Justification for Class III Permit Modification September 2005 SWMU 137 OU 1295 Building 6540/6542 Septic System at Technical Area III

Justification for Class III Permit Modification

SWMU 137

Building 6540/6542 Septic System at
Technical Area III

FIGURE 1-2
Site Map for ER Site 137
Sandia National Laboratories,
New Mexico

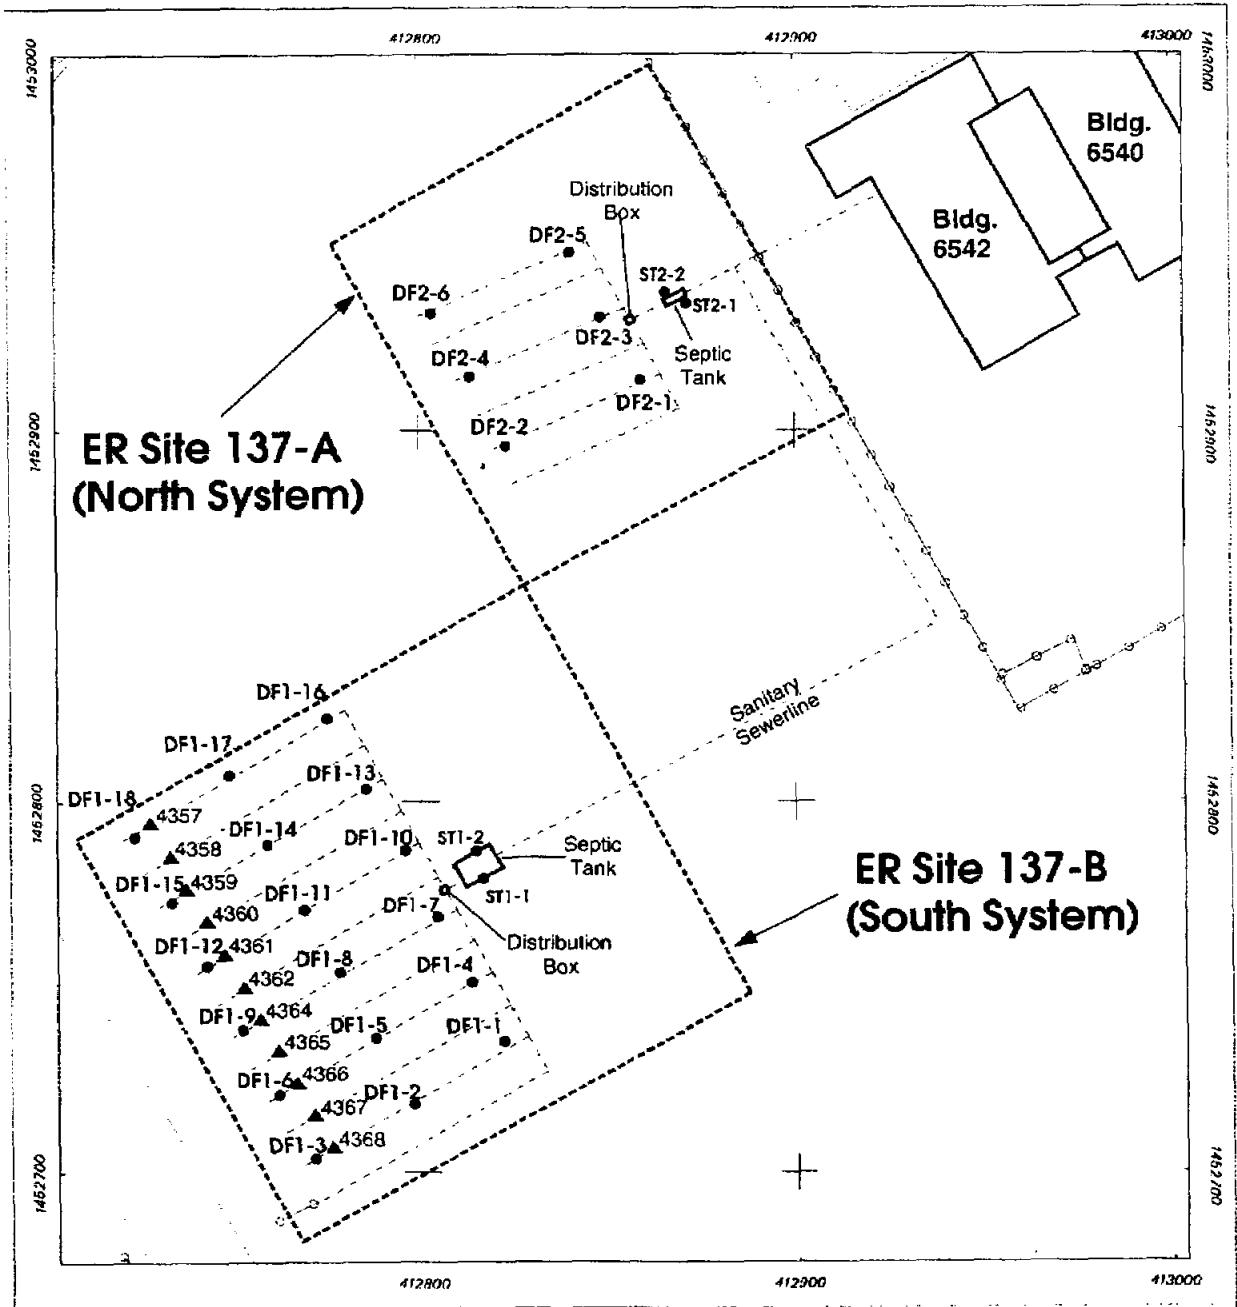
1. **The maps shown in Figures 1-1 and 1-2 are labeled "draft". See general comment 1.**

Response: Revised Figures 1-1 and 1-2 are provided without the word "draft" in Attachment A.
